Technical Bulletin

2017+ B&B Wreckers /w Walvoil SDS140 Valve System

by [B&B Parts Department](#) on March 26th, 2021

PTO Configuration-

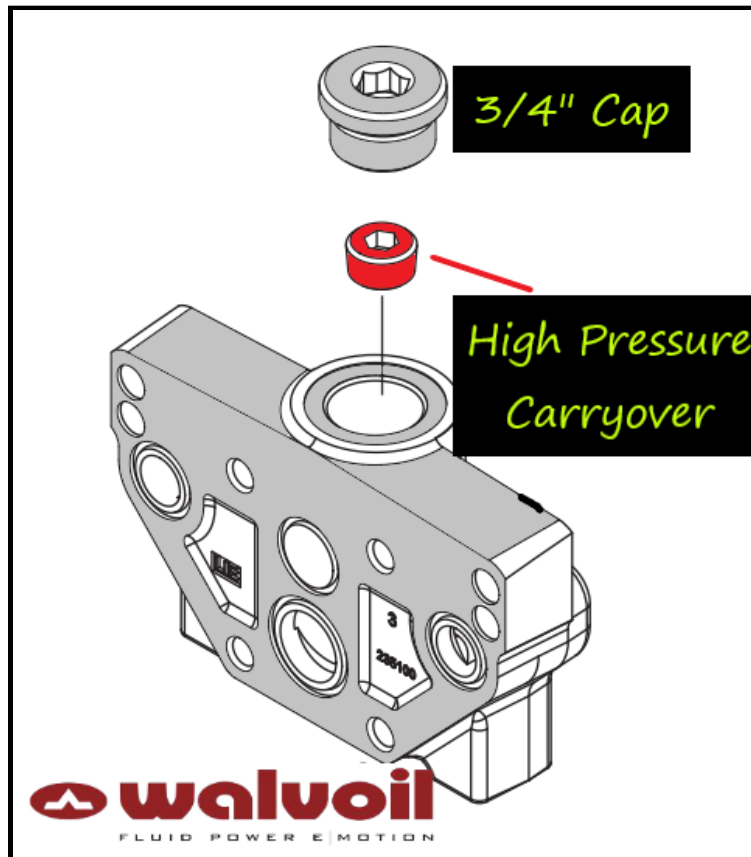
There are (2) types of PTO/Pump configurations that will determine what steps are needed to fix the problem, the type of configuration might shed some light on whether your unit is affected by this issue.

The High Pressure Carryover plug was meant for Single Pump / Dual Valve Body configuration. In this configuration, the 1st valve body (left) needs this plug to be installed to carry over high pressure to the secondary valve body (right). The High Pressure Carry Over plug **SHOULD NOT be installed** on the secondary (right) valve body, if installed it will cause these issues to arise.

The High Pressure Carryover plug **SHOULD NOT** be installed on either 1st(left) or secondary(right) valve body. With a Dual Pump / Dual Valve Body configuration, both valve bodies have their own pressure supply coming from a dedicated pump (dual pump), if these High Pressure Carryover plugs are installed on either valve bodies, it will cause these issues to arise.

1. On the Outlet Side (right side) of the valve body, remove the top 3/4" cap or attachment connected.
2. Remove the High Pressure Carryover plug located directly below the 3/4" cap. **If missing the problem has most likely been fixed previously.**
3. Replace 3/4" cap / attachment

*Note: In the past, owners were directed to turn up the valve body pressure as a fix to this issue, if the valve body pressure was previously turned up to compensate for this issue, it must be turned back down to the OEM pressure of **3200 PSI / GPM 20**. This should be tested and verified by a professional hydraulic shop / technician.
